V I L L A G E O F K E Y B I S C A Y N E

MEMORANDUM

DATE: October 18, 2016
TO: Honorable Mayor and Council Members
FROM: John C. Gilbert, Village Manager
RE: Site Plan Review: 401 Hampton Ln.

DT: October 18, 2016
TO: John C. Gilbert, Village Manager
FR: Jud Kurlancheek, AICP, Director
Building, Zoning, Planning and Public Works Department
RE: Site Plan Review: 401 Hampton Ln.

project name
CORNER PARK PERGOLA

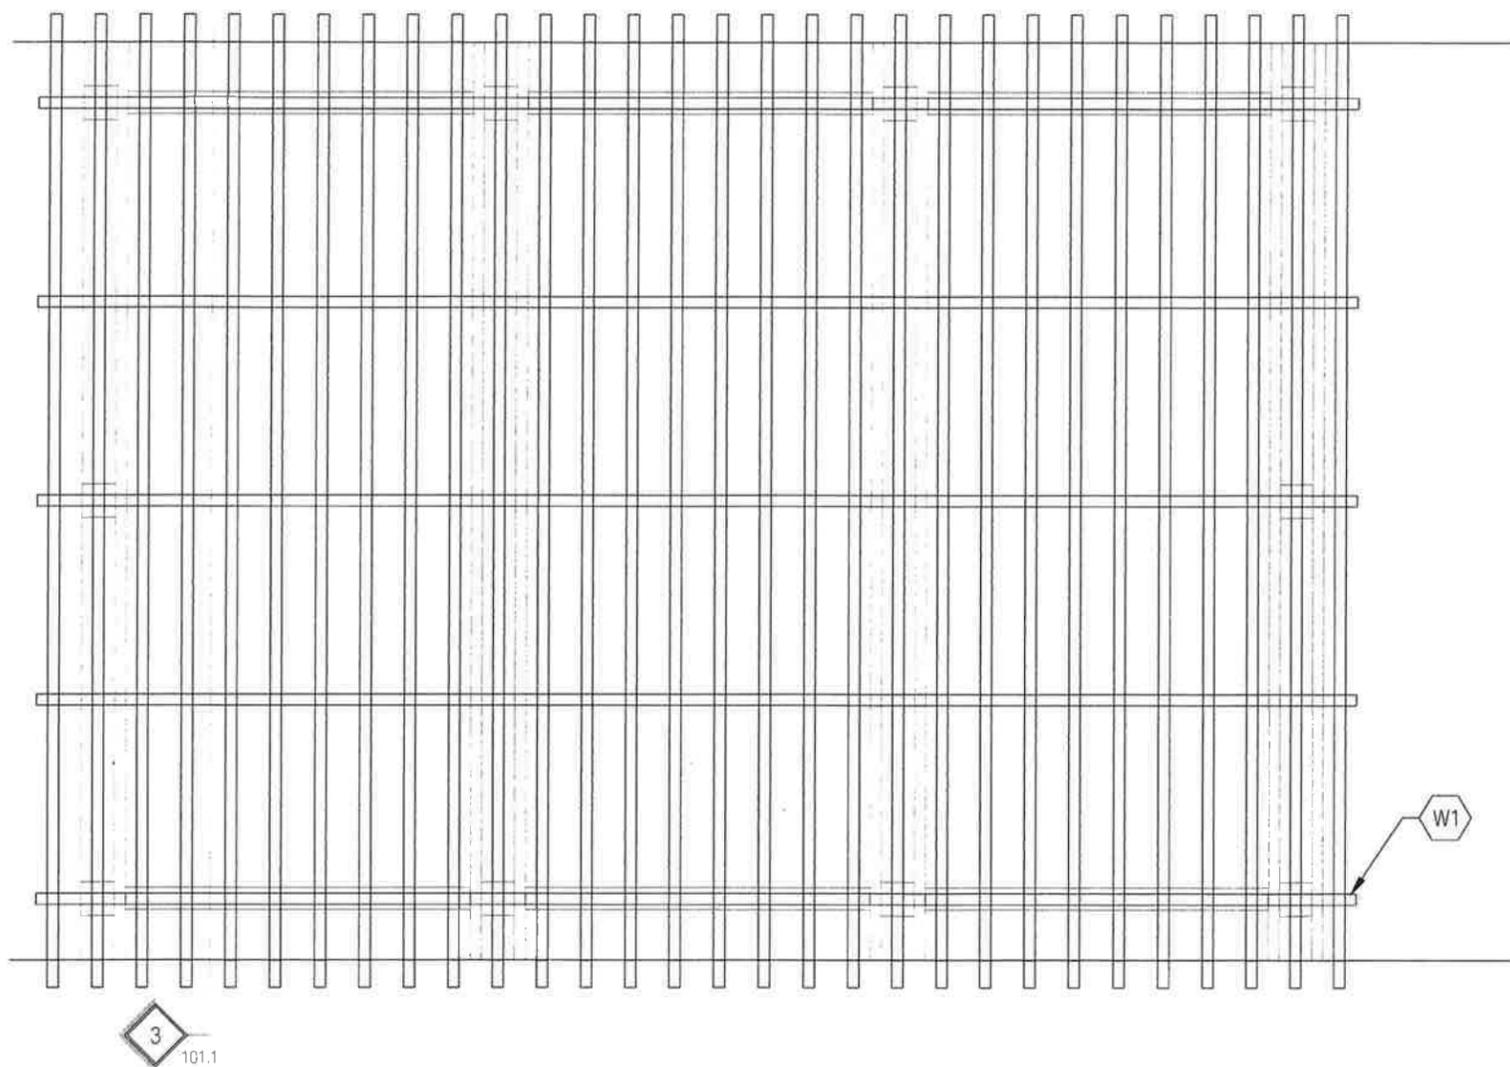
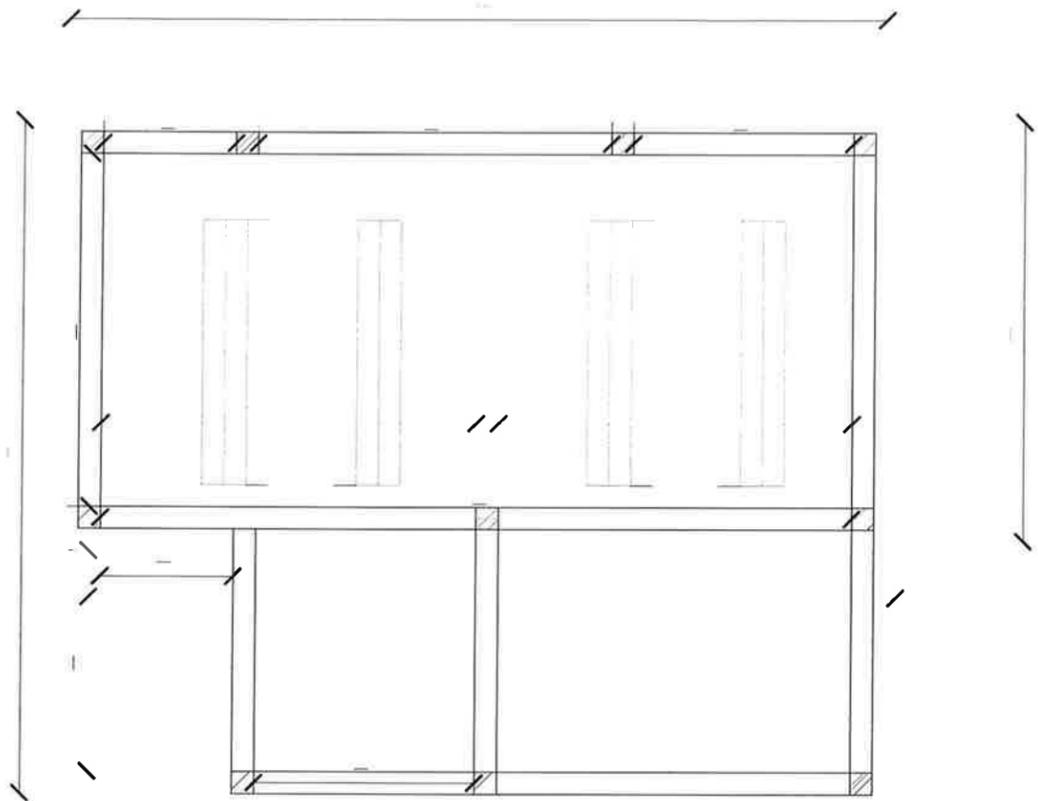
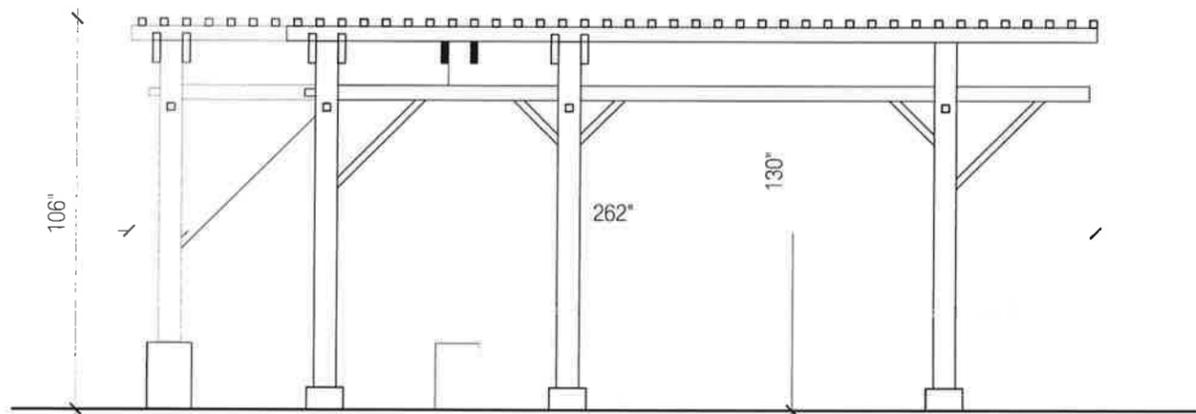
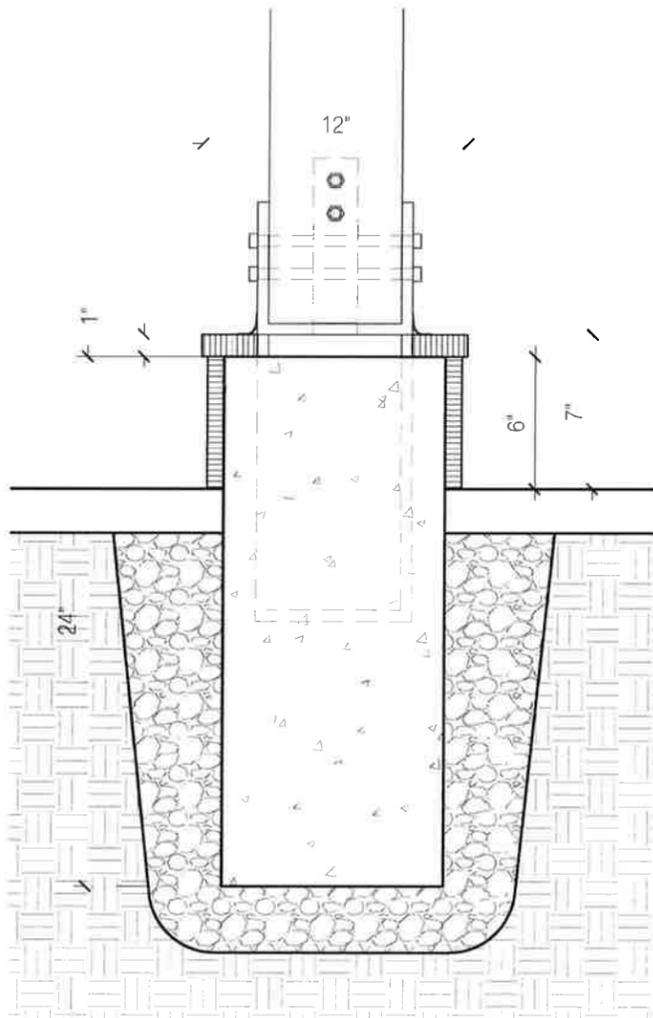
- a. The only building or structure is a pergola located inside the park near the pathway facing Hampton Ln. It will be wood, provide shade and be covered with landscaping. The location provides a view of the entire park. The style and texture of the pergola is found throughout the Village.
- b. The only building or structure is a pergola which measures 9 ft. 4 in. in height, 18 ft. long and 12 ft. wide from post to post. It is located inside the park near the pathway facing Hampton Ln. The pergola provides shade for two (2) pic-nick tables and an opportunity to observe activity in the park. It is open on all sides. There is an 8 ft. tall hill/berm that is located towards the center of the park which will be used by children. As such, there are no privacy issues.
- c. All signage will meet Village standards. There is no sign naming the park.
